Access Report

Collaroy Living Residences 37-43 Hay Street COLLAROY NSW

Ref: LP_22521

Figure 2 | Overall Site Plan

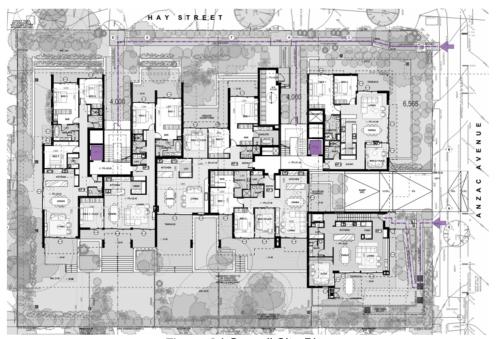
- from the allotment boundary at the pedestrian entrance along Hay Street and Anzac Avenue to the building entrance
- from the carparking area to the building entrance.

An accessible path of travel is provided to the building / apartment entrances from the allotment boundaries along Hay Street and Anzac Avenue. A system of walkways and ramps is provided.
